**Engineering Report: ER-157(NP-A) Rev. 8 &
Rev.8Errata**

**Supplement to Caldon Topical Report ER-80P:
Basis for Power Upgrades with an LEFM Check or an
LEFM CheckPlus System**

SUBJECT: FINAL SAFETY EVALUATION FOR CAMERON MEASUREMENT SYSTEMS
ENGINEERING REPORT ER-157P, REVISION 8, "CALDON ULTRASONICS
ENGINEERING REPORT ER-157P, 'SUPPLEMENT TO TOPICAL REPORT
ER-80P: BASIS FOR A POWER UPRATE WITH THE LEFM CHECK OR
CHECKPLUS SYSTEM'," (TAC NO. ME1321)

FINAL SAFETY EVALUATION BY THE OFFICE OF NUCLEAR REACTOR REGULATION

Figure 2: Diagram of a One Loop LEFM CheckPlus System

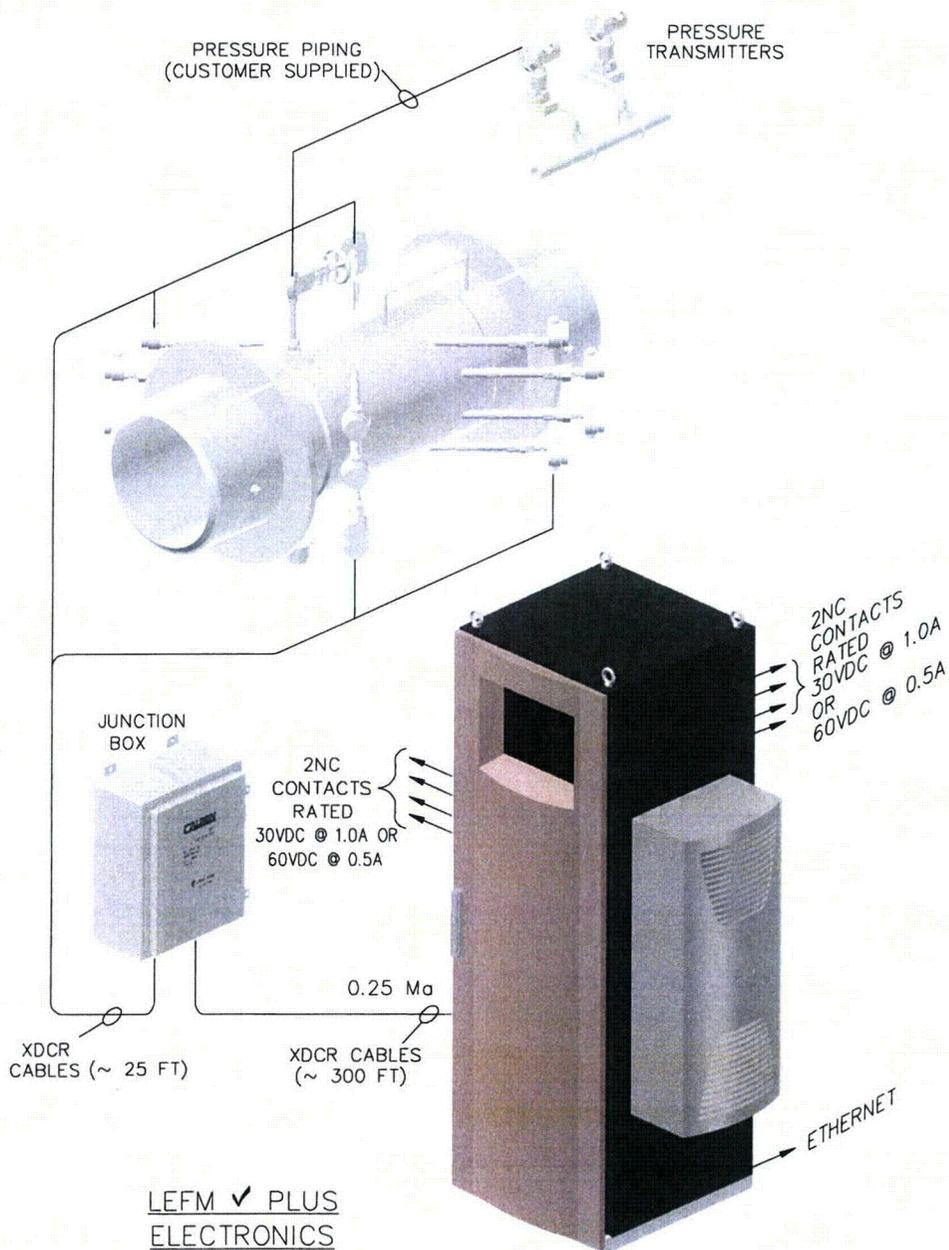
1. Page 4: Change the first sentence to read:
“An LEFM CheckPlus system is illustrated in Figure 2.”
2. Page 6, first paragraph after bulleted list, second sentence, add a foot note after “component failure*” as follows:
“* A component failure is defined as a failure of any single subassembly of the LEFM measurement system, such as a power supply, a transducer, an acoustic processor (transmitter/receiver), or a (digital) processor.”
3. Page 6, first paragraph after bulleted list, third sentence, insert the word “component” between “single” and “failure”.
4. Page 6, second paragraph after bulleted list, first sentence, change “principle” to “principal”.
5. Page 6, second paragraph after bulleted list, last sentence, insert the word “component” between “single” and “failure”.
